Quality Notes

Roof Accessories - 01

7-31-2012

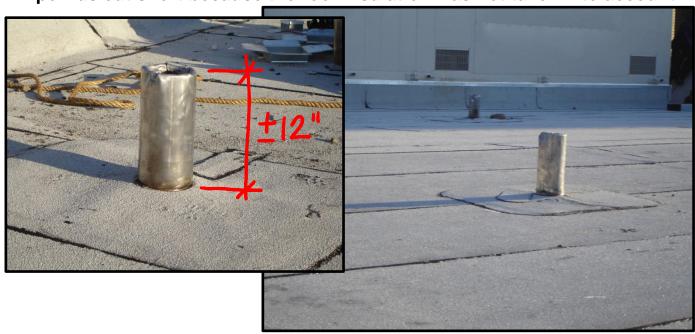
Make sure that the pipes which penetrate the roof has the proper height above the finish roof level – and always review when we do roof replacements:

Pipe was cut short because the roof insulation was not taken into account.

The Pipe should be about 12" (IL Plumbing Code 089.1430a) or more above the finished elevation of the roof.

Take into account tapered insulation.
